Addendum #2 – Final Core & Shell Package

Project Name: Hudl HQ – New Office / Mixed Use Building
Lincoln, NE
Project No.: 15024
Issued: January 26, 2016
Bid Date: 2:00 PM CST, Tuesday, February 2, 2016
Bid Opening: Sampson Construction
Location: 3730 South 14th Street
Lincoln, NE 68502

EXHIBIT
C2-1

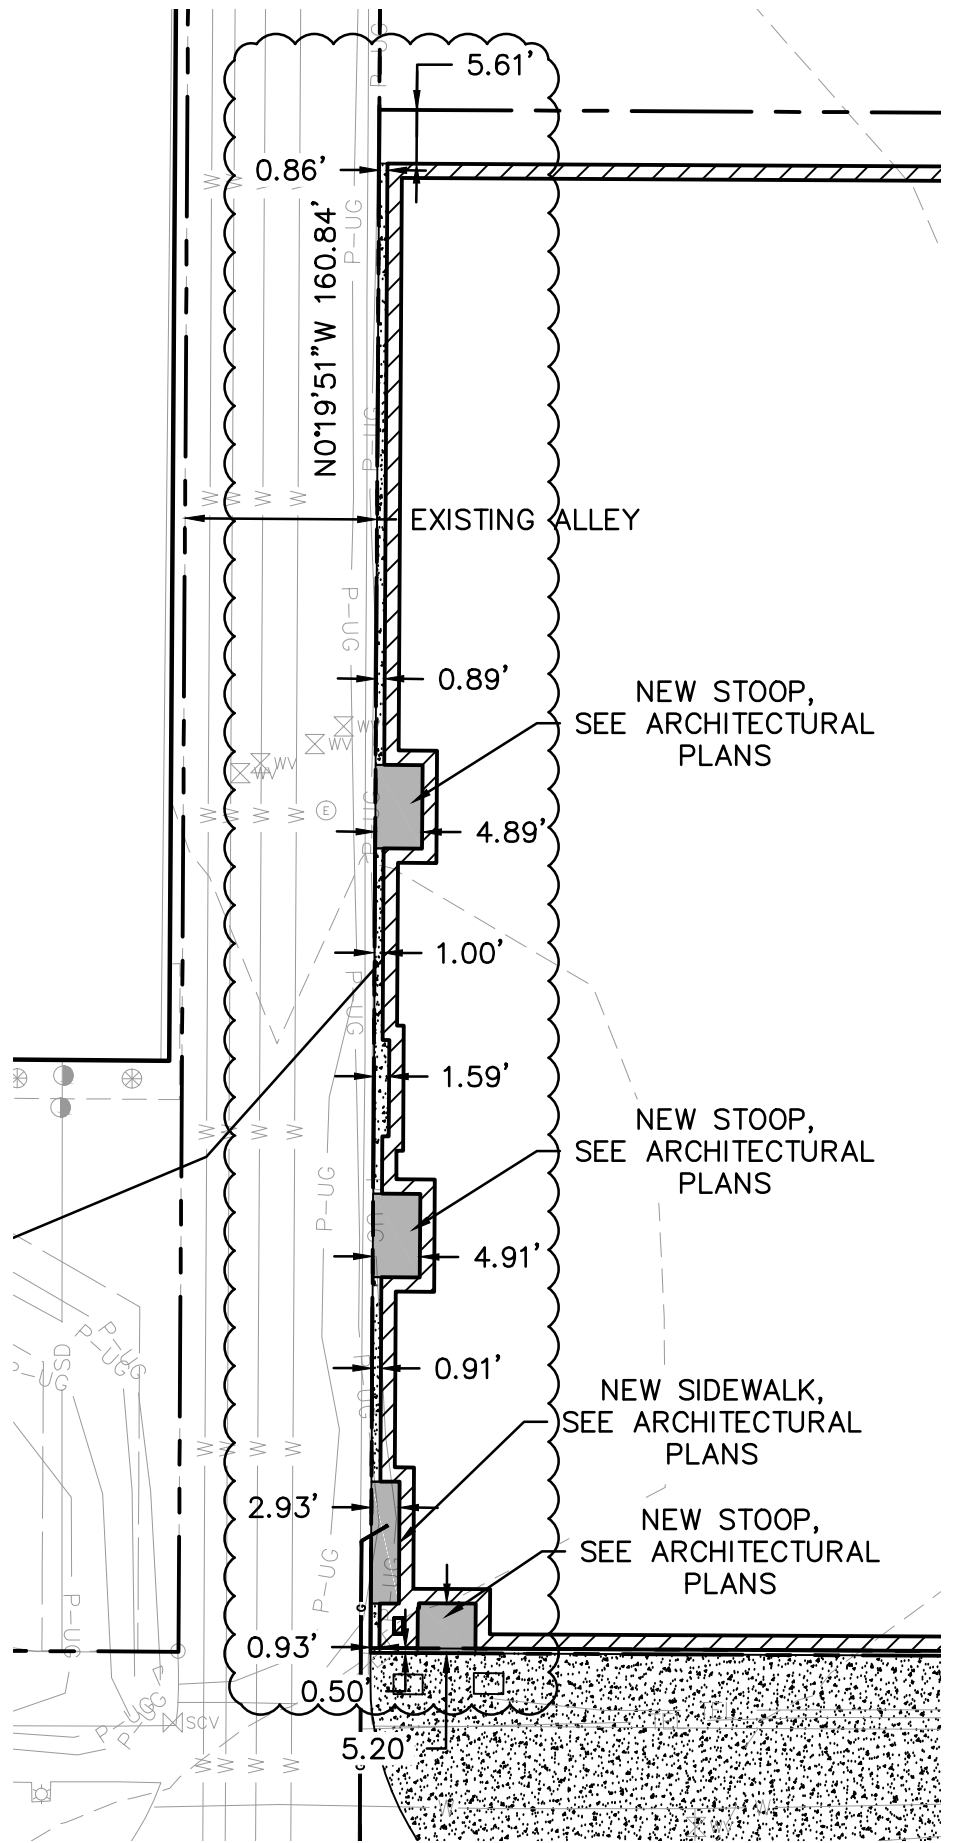
- ADD 2-27.** Refer to Sheet C500, Detail 12/C500. Benches to anchor to concrete base. No footing required.
- ADD 2-28.** Refer to Sheet C100, Limits of alley tie in are between building and alley along the west side. See **Attachment C2-1.**

Revision to Sheet: **E401**

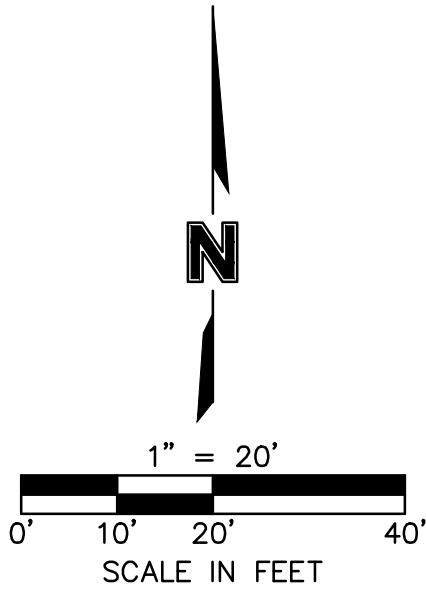
- ADD 2-37.** Revision to E113. Revised Note 3 to clarify intent for junction box. Refer to **Attachment E2-2.**
- ADD 2-38.** Revision to E401. Revised Note 4 to clarify that relay panel should be 32 circuit as indicated on 1/E504. Refer to **Attachment E2-3.**

- REQUIREMENTS WITH PLUMBING CONTRACTOR
PRIOR TO ROUGH-IN.
4. PROVIDE 32 CIRCUIT RELAY PANEL. REFER TO E504 FOR ADDITIONAL INFORMATION.
 5. PROVIDE ROUGH-IN AND POWER TO DOOR

Revision to Sheet: **E402**

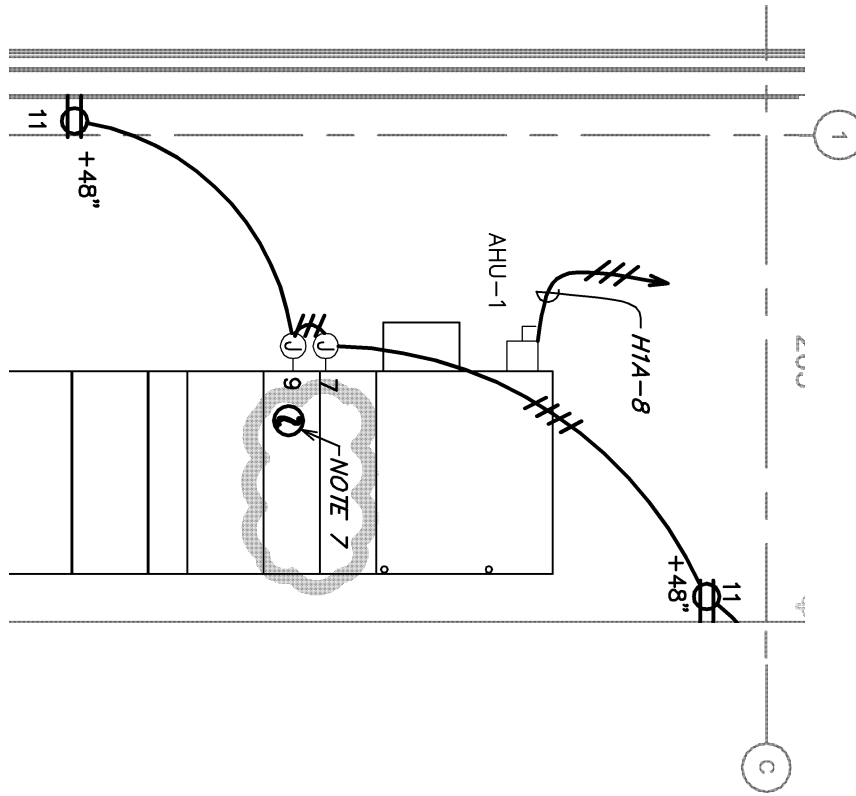
- ADD 2-39.** Revision to E402. Added Note 6 to clarify intent of junction boxes added in Addendum 1. Added duct smoke detector for AHU as shown previously on mechanical drawings. Refer to **Attachment E2-4.**

7. SUPPLY FAN SHUTDOWN SHALL BE FURNISHED BY THE ELECTRICAL CONTRACTOR FOR INSTALLATION BY THE MECHANICAL CONTRACTOR. THE ELECTRICAL CONTRACTOR SHALL ALSO PROVIDE A REMOTE KEYED TEST STATION WITH VISUAL STATUS ANNUNCIATOR WHEN DUCT SMOKE DETECTOR IS INSTALLED IN A CONCEALED LOCATION GREATER THAN 10'-0" ABOVE FINISHED FLOOR OR WHEN DUCT SMOKE DETECTOR'S STATUS INDICATORS ARE NOT READILY VISIBLE. COORDINATE LOCATION OF REMOTE KEYED TEST STATION WITH AUTHORITY HAVING JURISDICTION AND OWNER PRIOR TO ROUGH-IN. ALL FINAL WIRING SHALL BE BY THE ELECTRICAL CONTRACTOR.

Revision to Sheet: **E403**

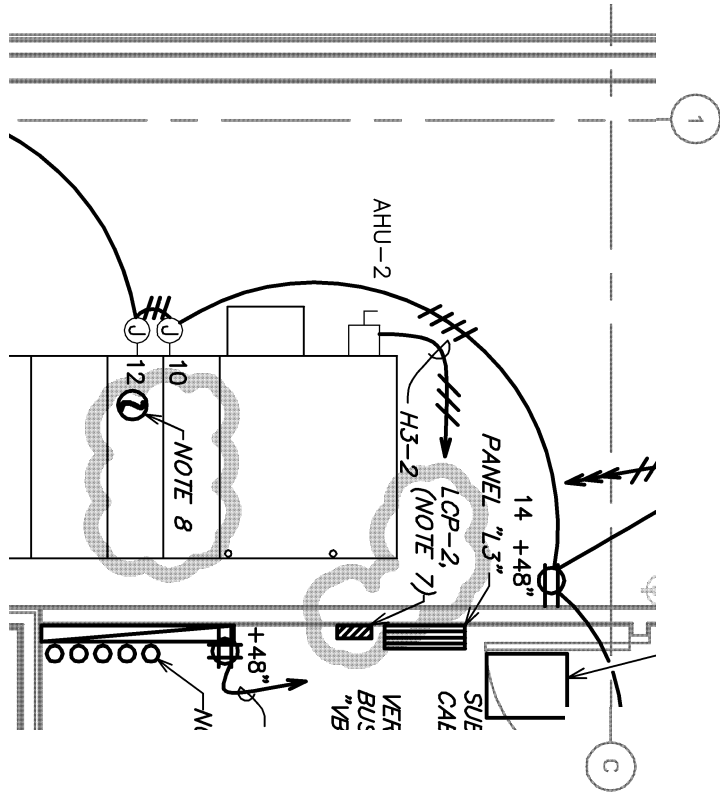
- ADD 2-40.** Revision to E403. Added Note 6 to clarify intent of junction boxes added in Addendum 1. Added duct smoke detector for AHU as shown previously on mechanical drawings. Added location for LCP-2 indicated on E504. Refer to **Attachment E2-5.**

7. PROVIDE 8 CIRCUIT RELAY PANEL. REFER TO E504 FOR ADDITIONAL INFORMATION. SUPPLY FAN SHUTDOWN SHALL BE FURNISHED BY THE ELECTRICAL CONTRACTOR FOR INSTALLATION BY THE MECHANICAL CONTRACTOR. THE ELECTRICAL CONTRACTOR SHALL ALSO PROVIDE A REMOTE KEYED TEST STATION WITH VISUAL STATUS ANNUNCIATOR WHEN DUCT SMOKE DETECTOR IS INSTALLED IN A CONCEALED LOCATION GREATER THAN 10'-0" ABOVE FINISHED FLOOR OR WHEN DUCT SMOKE DETECTOR'S STATUS INDICATORS ARE NOT READILY VISIBLE. COORDINATE LOCATION OF REMOTE KEYED TEST STATION WITH AUTHORITY HAVING JURISDICTION AND OWNER PRIOR TO ROUGH-IN. ALL FINAL WIRING SHALL BE BY THE ELECTRICAL CONTRACTOR.

Revision to Sheet: **E404**

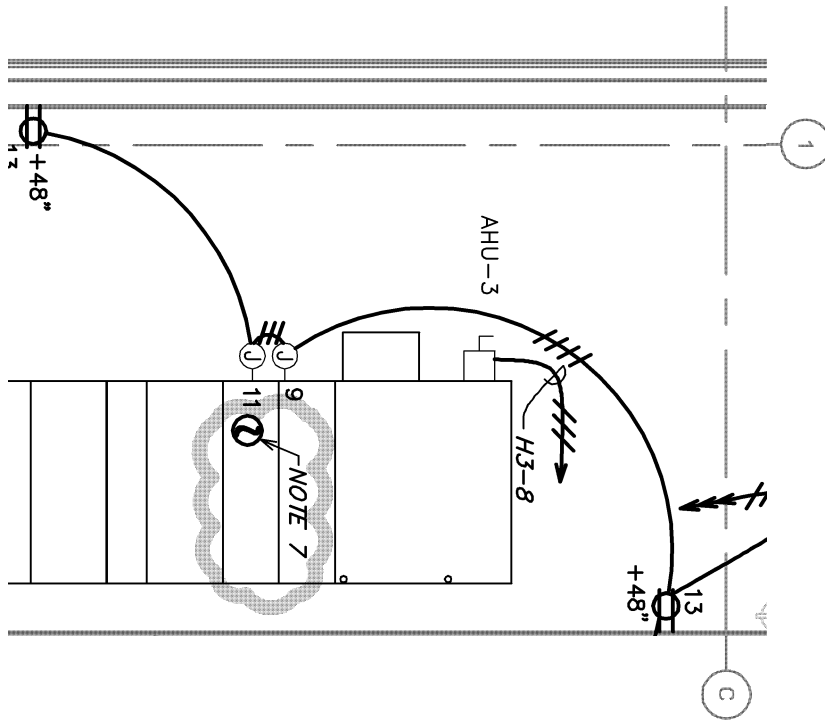
- ADD 2-41.** Revision to E404. Added Note 6 to clarify intent of junction boxes added in Addendum 1. Added duct smoke detector for AHU as shown previously on mechanical drawings. Refer to **Attachment E2-6.**

Revision to Sheet: **E405**

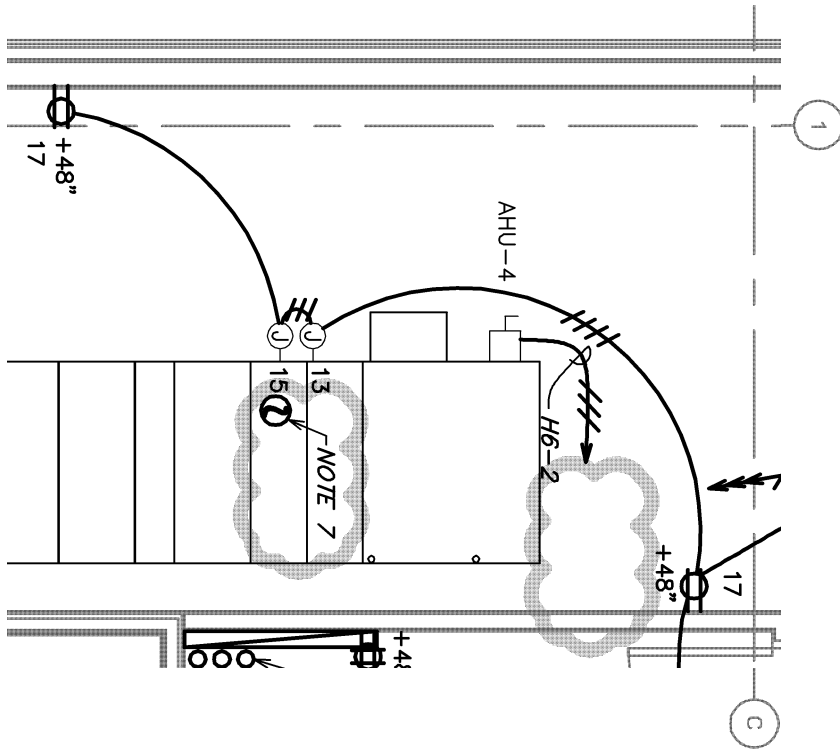
Question: *On sheet E405 Detail A1 in mechanical room 505 we see an EMS Panel. Who is to supply this panel and do we need to figure power for this panel?*

- ADD 2-42.** Revision to E405. Added Note 6 to clarify intent of junction boxes added in Addendum 1. Added duct smoke detector for AHU as shown previously on mechanical drawings. Removed reserved space for EMS panel from the plan, this space is still shown on the mechanical drawings. Refer to **Attachment E2-7.**

Response: This is reserved space for a future EMS panel. This EMS panel was removed from E405, refer to attachment E2-7.

Revision to Sheet: **E406**

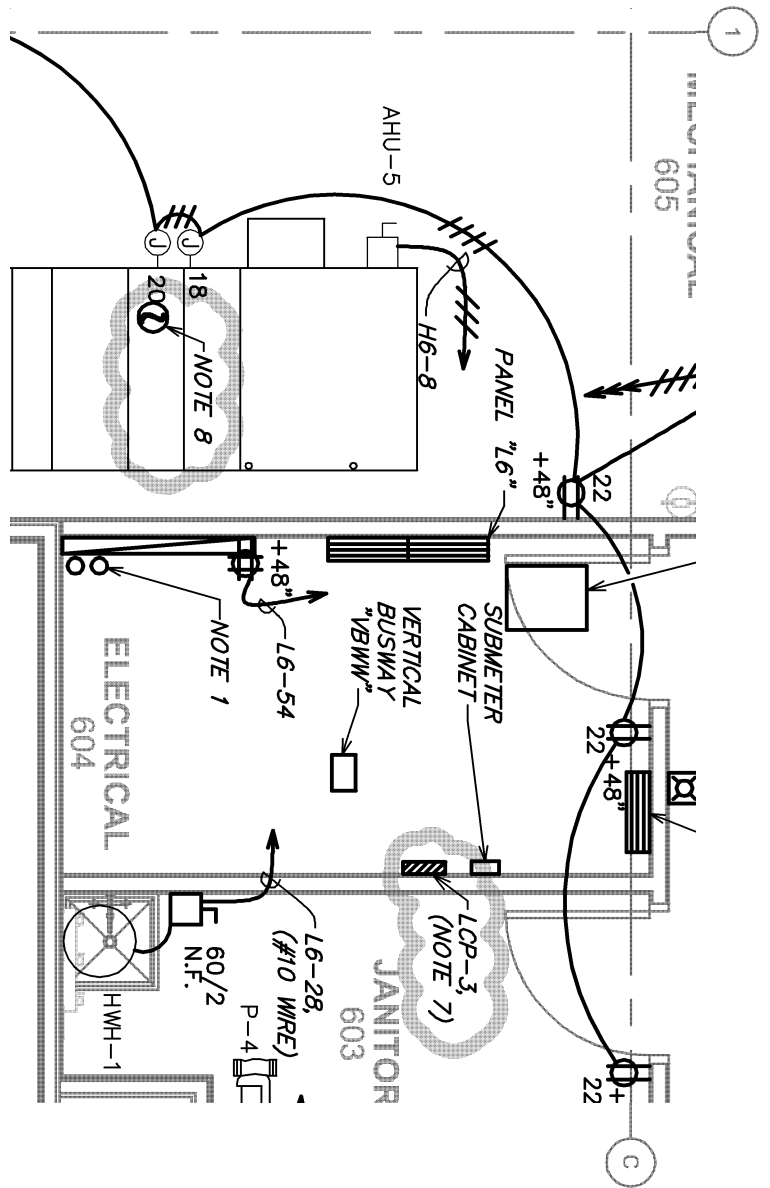
- ADD 2-43.** Revision to E406. Added Note 6 to clarify intent of junction boxes added in Addendum 1. Added duct smoke detector for AHU as shown previously on mechanical drawings. Added location for LCP-3 indicated on E504. Refer to **Attachment E2-8.**

7. PROVIDE 16 CIRCUIT RELAY PANEL. REFER TO SUPPLY FAN SHUTDOWN SHALL BE FURNISHED BY THE ELECTRICAL CONTRACTOR FOR INSTALLATION BY THE MECHANICAL CONTRACTOR. THE ELECTRICAL CONTRACTOR SHALL ALSO PROVIDE A REMOTE KEYED TEST STATION WITH VISUAL STATUS ANNUNCIATOR WHEN DUCT SMOKE DETECTOR IS INSTALLED IN A CONCEALED LOCATION GREATER THAN 10'-0" ABOVE FINISHED FLOOR OR WHEN DUCT SMOKE DETECTOR'S STATUS INDICATORS ARE NOT READILY VISIBLE. COORDINATE LOCATION OF REMOTE KEYED TEST STATION WITH AUTHORITY HAVING JURISDICTION AND OWNER PRIOR TO ROUGH-IN. ALL FINAL WIRING SHALL BE BY THE ELECTRICAL CONTRACTOR.

Revision to Sheet: **E407**

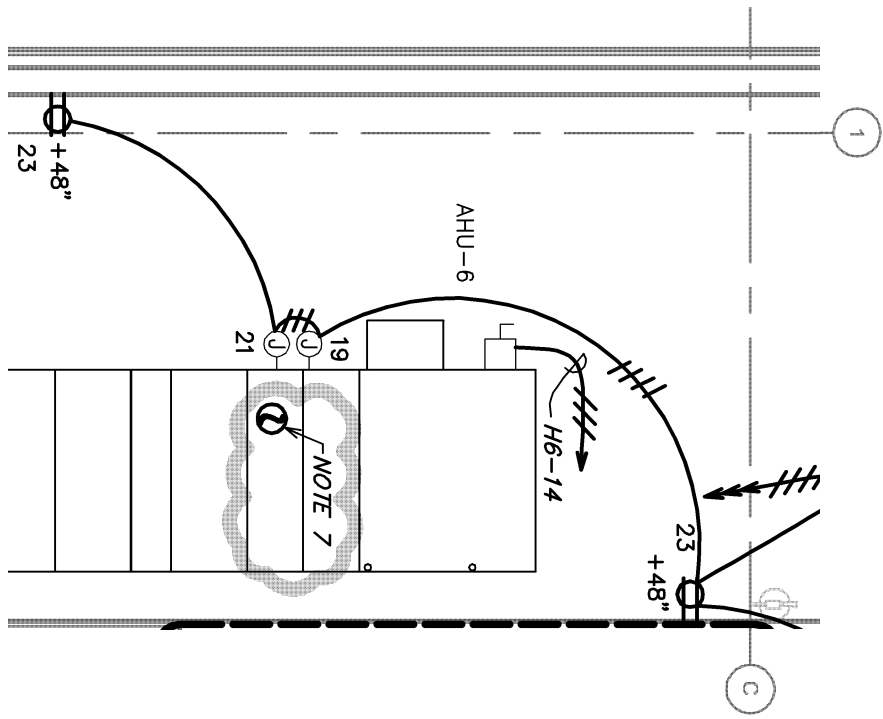
- ADD 2-44.** Revision to E407. Added Note 6 to clarify intent of junction boxes added in Addendum 1. Added duct smoke detector for AHU as shown previously on mechanical drawings. Refer to **Attachment E2-9.**

Revision to Sheet: E611

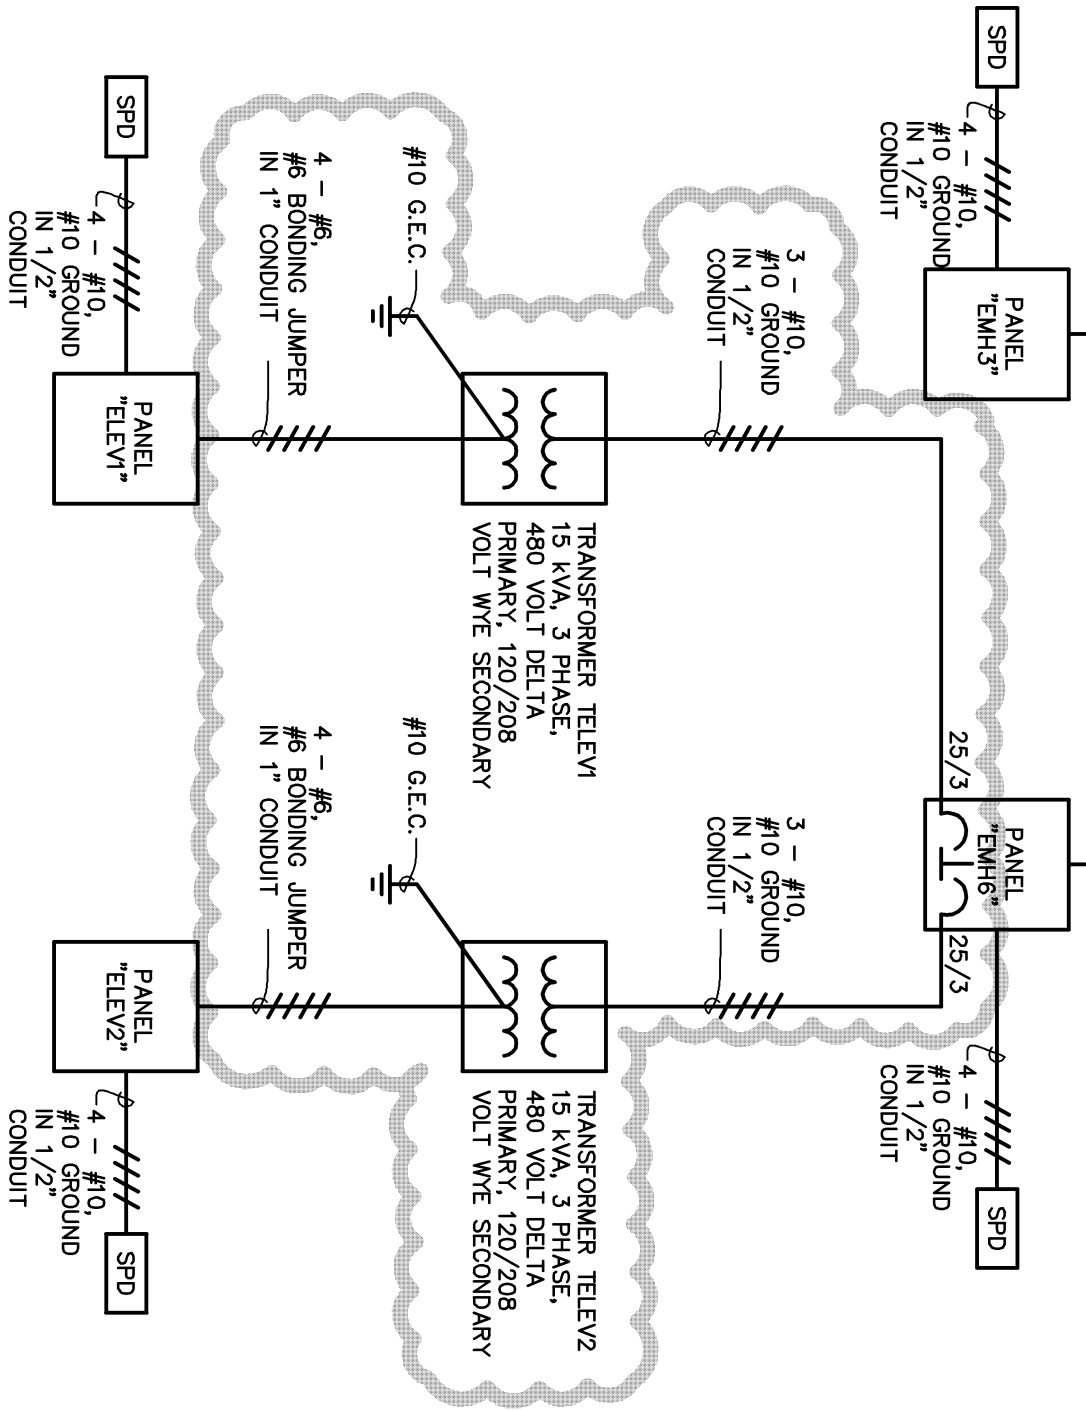
- ADD 2-45.** Revision to E603. Added panel schedule for Panel H2A serving electric heaters on ground level. Refer to **Attachment E2-10.**
- ADD 2-46.** Revision to E611. Noted primary and secondary feeders for panels ELEV1 and ELEV2. Refer to **Attachment E2-11.**

Revision to Sheet: **E611**

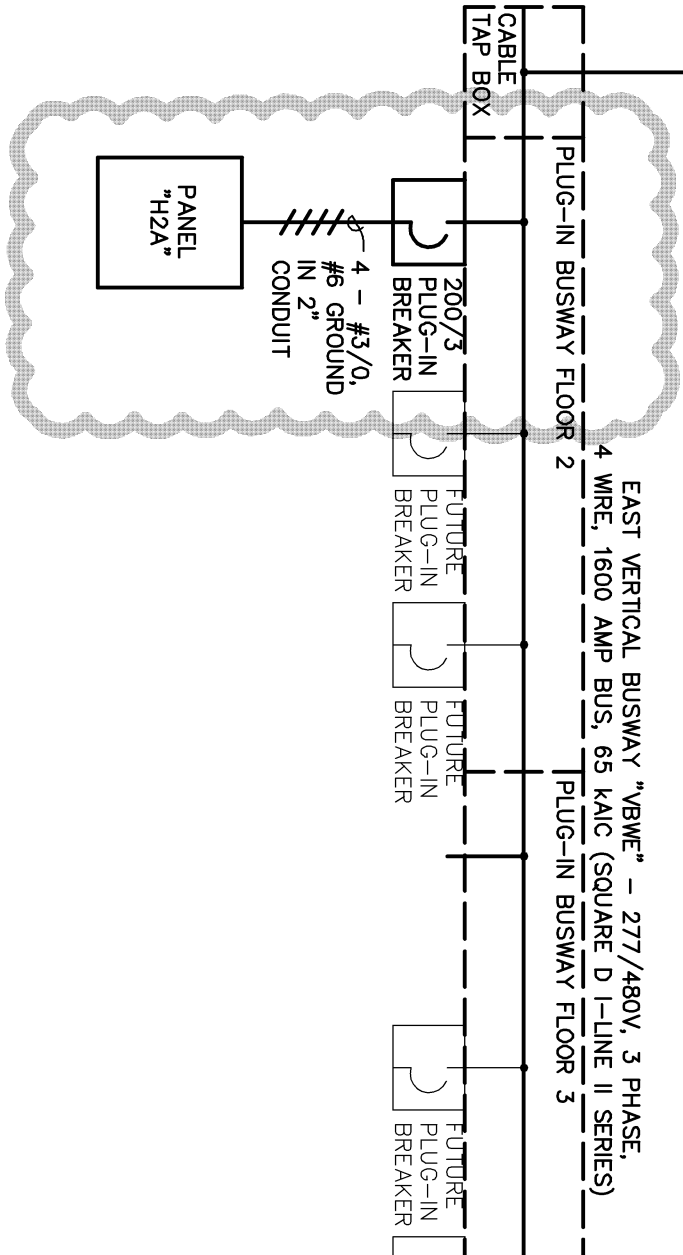
Question: *Can you please expand on the Submeter Cabinets that are shown on the drawings? I'm not finding any information on this item in the bidding documents.*

- ADD 2-47.** Added panel H2A and associated feeders to one-line diagram. Added boxed note clarifying the submeter cabinet for each electrical room. Refer to **Attachment E2-12.**

Response: The submeter cabinets should be Emon Dmon MMU8 cabinets with space for eight submeters. This is now noted on sheet E611, refer to attachment E2-12.

PROVIDE EMON DMON MMUB
 SUBMETER CABINET IN EACH
 ELECTRICAL ROOM ON FLOORS
 2-7. REFER TO ELECTRICAL
 PLANS FOR LOCATION IN EACH
 ROOM.
